# **Intel<sup>®</sup> Pentium<sup>®</sup> III Xeon<sup>™</sup> Processor Specification Update**

Release Date: July 2000

Order Number: 244460-017

The Pentium<sup>®</sup> III Xeon processor may contain design defects or errors known as errata which may cause the product to deviate from published specifications. Current characterized errata are documented in this Specification Update.

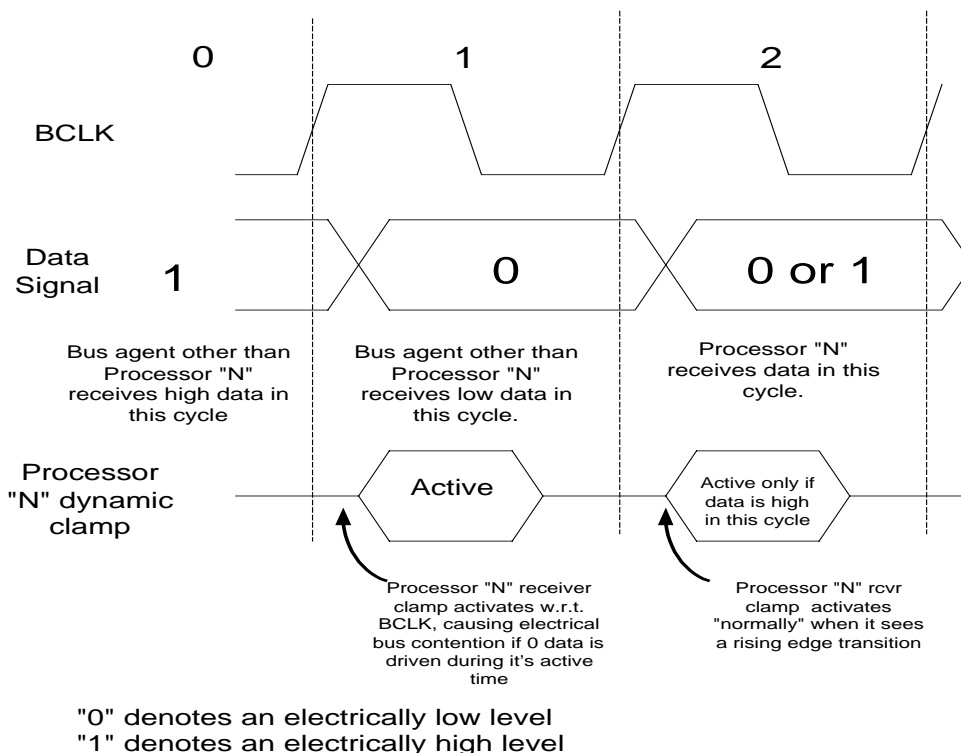
**Workaround:** The AGTL+  $V_{REF}$  (input voltage reference) level will be raised from 1.0V to 1.1V (assuming a  $V_{TT}$  of 1.5V) on the processor cartridge substrate. This allows the dynamic clamp to activate at a trigger level approximately 100 mV higher than with the previous 1.0V  $V_{REF}$  setting. Due to the dependence upon system bus design, bus layout may be evaluated to determine the need for improvements in falling edge ringback levels. This may involve one or several of the following baseboard modifications:

1. Change termination resistor value to reduce multi-bit noise and/or improve  $V_{IL}$  noise margin.
2. Reduce multi-bit noise by improving ground return paths (additional high-frequency decoupling, improved AC plane referencing, etc.).
3. Raising or lowering the  $V_{TT}$  level (within the AC & DC tolerances specified in the processor EMTS) to improve  $V_{IL}$  noise margin and/or reduce the multi-bit noise due to  $di/dt$  transients.

Stress tests using various data patterns and transactions should be run to identify the worst-case multi-bit noise conditions for this erratum.
